Subject: AP1000 COL Response to Request for Additional Information (TR 36)

Response to Request for Additional Information on Technical Report No. 36

RAI Response Number: RAI-TR36-012

Figure 4-1

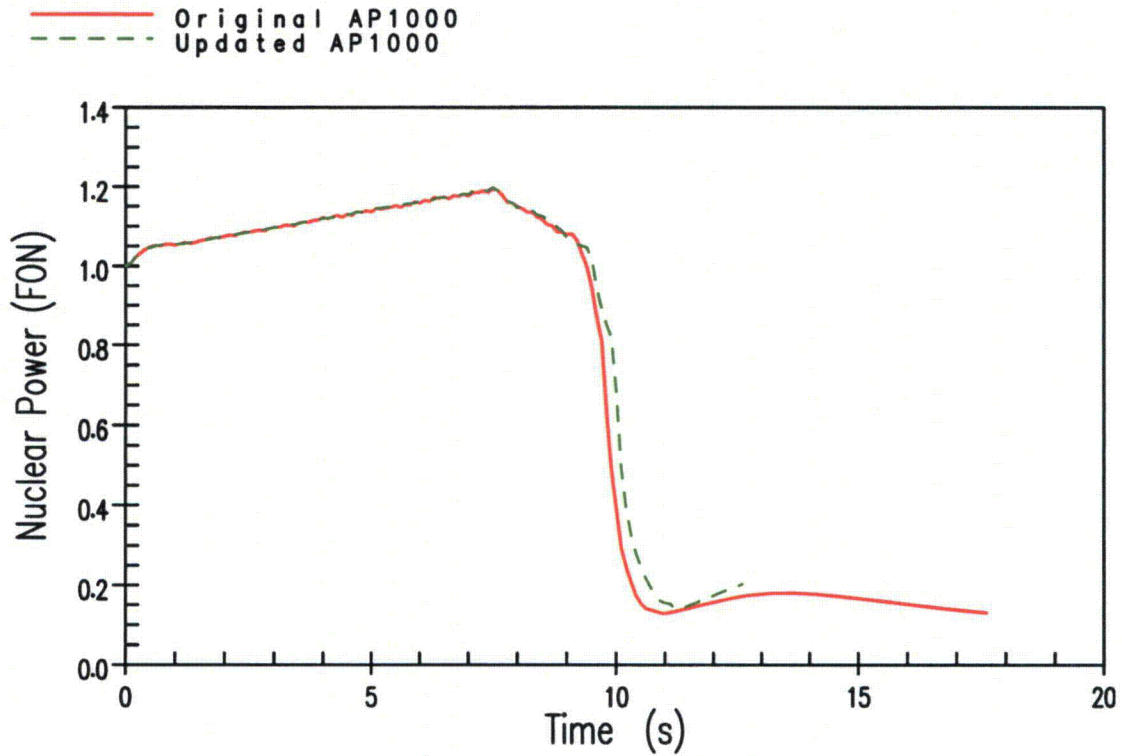
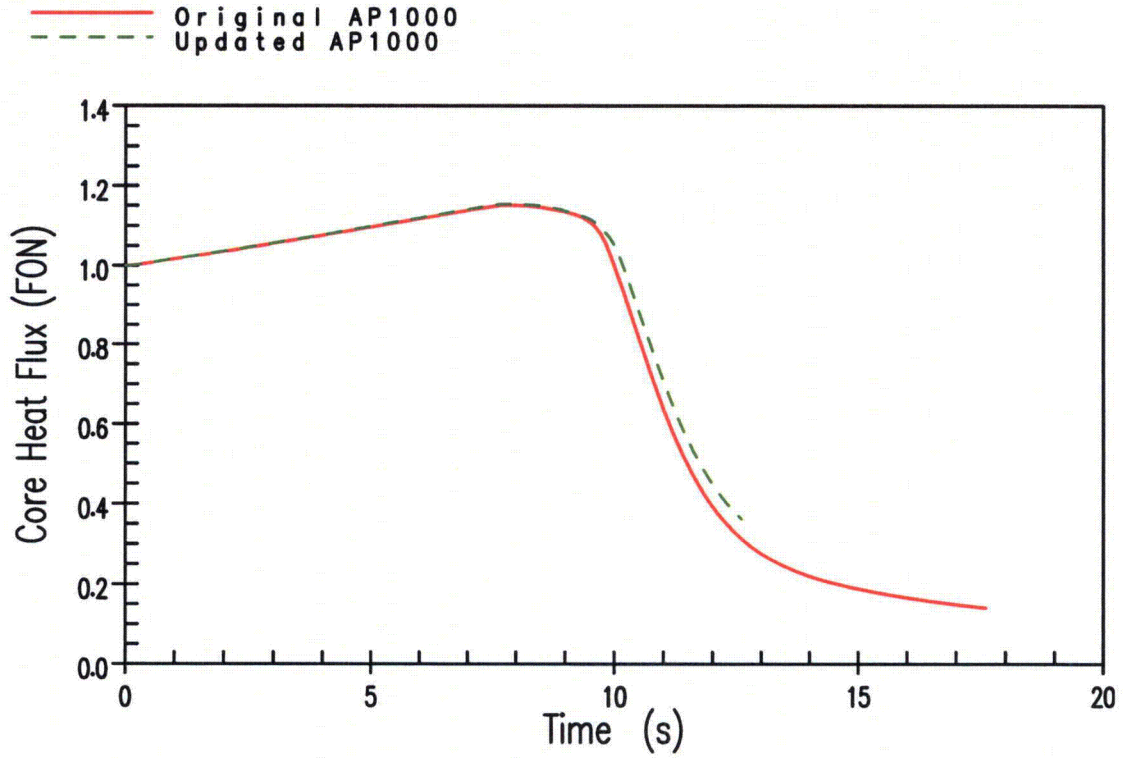
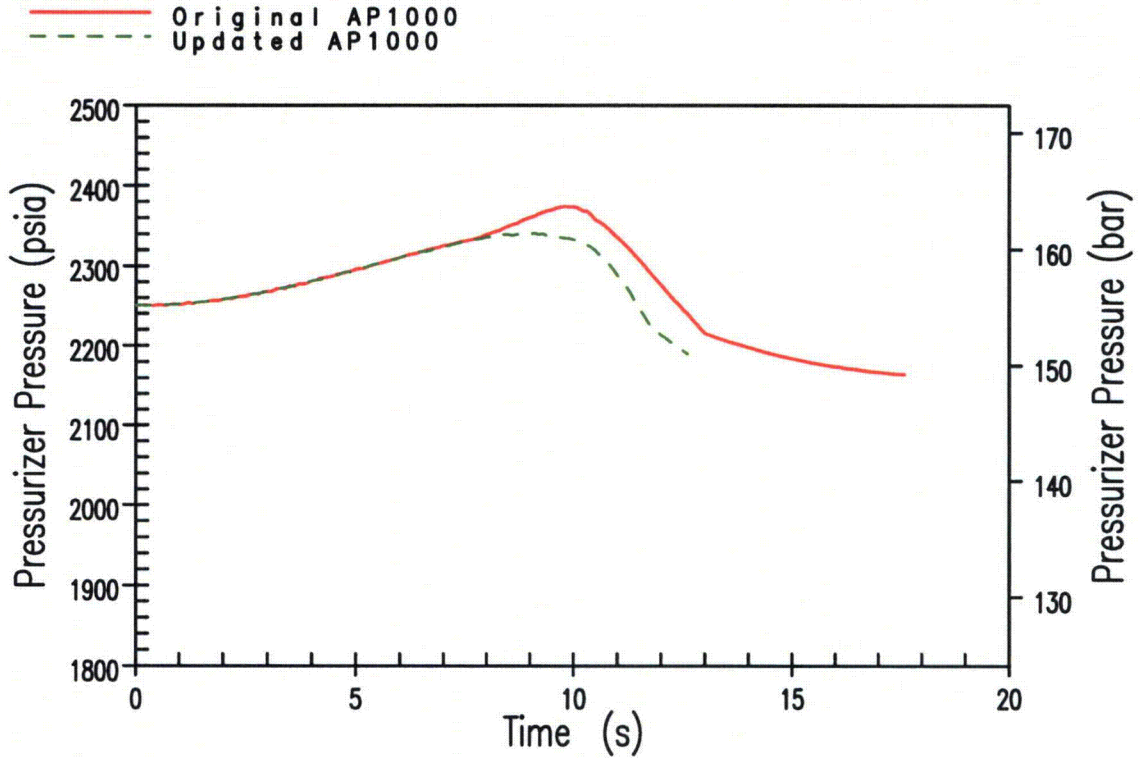
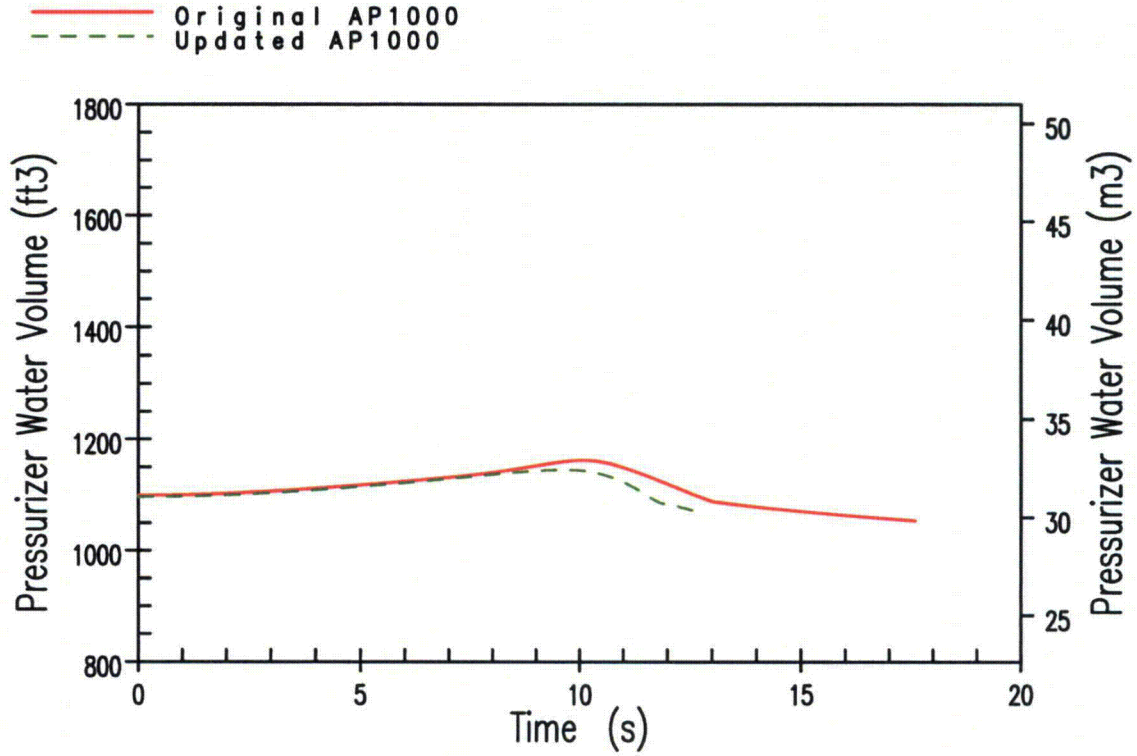
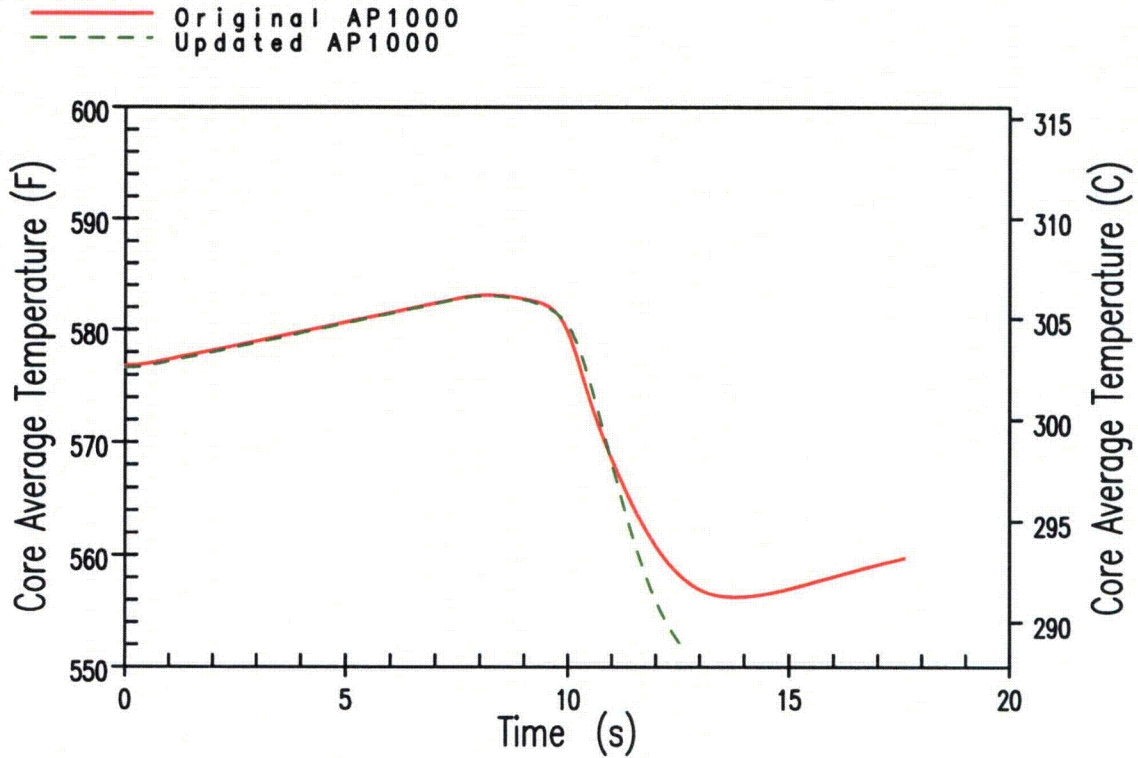
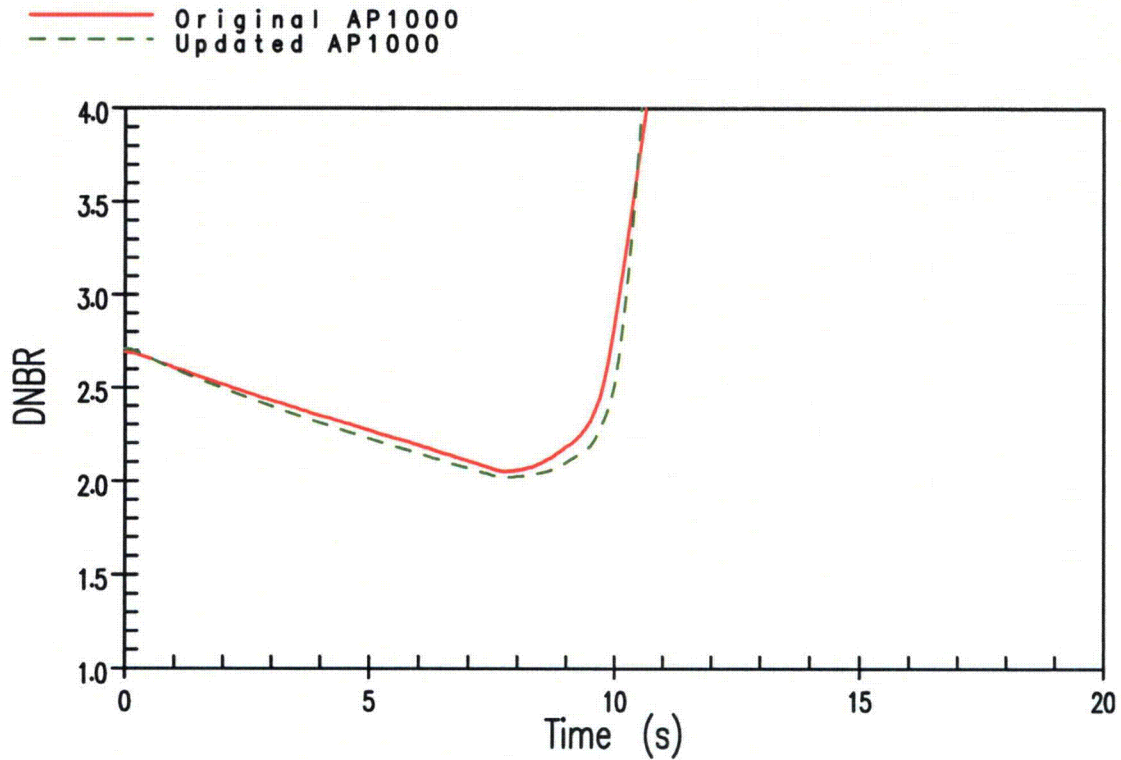
The pressurizer changes affect many parameters such as the cross-sectional area of the pressurizer, pressurizer vessel height, initial pressurizer water level, pressurizer setpoints, ADS stages 1, 2, and 3 elevation and pressurizer heater length. We are concerned about the combined effects of the values changed for the above parameters on the thermal hydraulic response during transient and accident conditions. We determined that the qualitative statement in the RAI response is not sufficient to resolve the RAI issue. We request Westinghouse perform the quantitative analyses for the limiting event for each of the following Standard Review Plan chapter 15 event categories:

The transient results are provided for two of the RCCA bank withdrawal cases which were analyzed. Figures 4-1 through 4-6 compared the results of the original AP1000 configuration to the updated configuration for a high reactivity insertion rate (75 pcm/s) from full power. A sequence of event for this case is provided in Table 4-1. The high reactivity insertion rate case trips the reactor on a high nuclear flux signal. The trends and timing for high reactivity insertion rate case is not significantly changed from the original AP1000 configuration. As shown in Figure 4-6, the DNB ratio is maintained above the safety analysis limit value of 1.5 for this case.
